Access Compliance Report

Public Rights-of-Way

(Curb Ramps)

Intersection ID: 10026799	Main Street: FOREST_POINT_BV	Cross Street: N/A	Location: NE
ADA ID: A18BA71CB669	Ramp Type: PerpDiag	Initial Pass/Fail: Fail	Overall Compliance: No
		Severity Score: 12.5

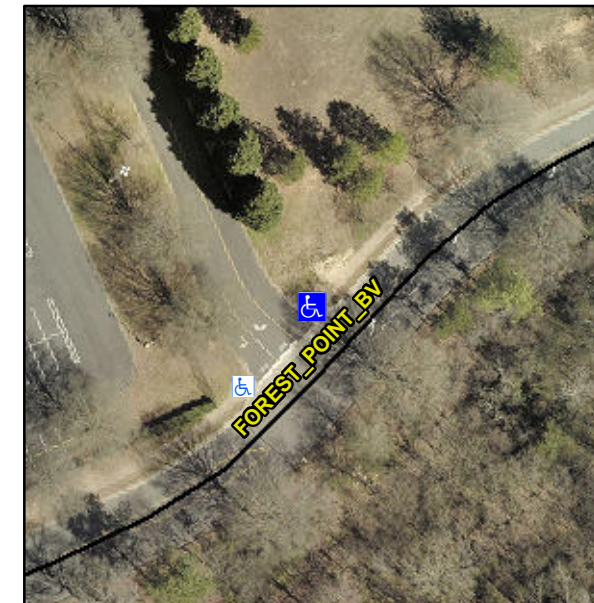
Not Found, R304.5.3

Compliance	Description	Data	Compliance	Description	Data
N/A	Ramp Length (in)	120.0	Yes	Ramp Slope (%)	5.7
Yes	Ramp Width (in)	48.0	No	Ramp XSlope (%)	5.7
N/A	Flare Type LT	N/A	N/A	Flare Type RT	N/A
N/A	Flare Slope LT (%)	N/A	N/A	Flare Slope RT (%)	N/A
N/A	Flare Traversable LT?	N/A	N/A	Flare Traversable RT?	N/A
N/A	Landing Length (in)	N/A	N/A	DWS Provided?	N/A
N/A	Landing Width (in)	N/A	N/A	DWS Contrast?	N/A
N/A	Landing Slope (%)	N/A	N/A	DWS Length (in)	N/A
N/A	Landing X Slope (%)	N/A	N/A	DWS Full Width?	N/A
N/A	Landing Curb? (Y/N)	N/A	N/A	DWS Offset (in)	N/A
N/A	Shared Landing?	N/A			
N/A	Gutter Ponding?	N/A	N/A	Gutter Slope (%)	N/A
N/A	Gutter Lip Ht (in)	N/A	N/A	Gutter X Slope (%)	N/A
N/A	Painted X Walk1?	No	N/A	Painted X Walk2?	No
	X Walk 1 Direction	To SW		X Walk 2 Direction	To S
N/A	X Walk 1 Width (in)	N/A	N/A	X Walk 2 Width (in)	N/A
	X Walk 1 Slope (%)	2.0		X Walk 2 Slope (%)	4.3
	X Walk 1 X Slope (%)	5.4		X Walk 2 X Slope (%)	1.9

Remove & Replace Curb Ramp With Two New Directional Ramps or Equivalent.
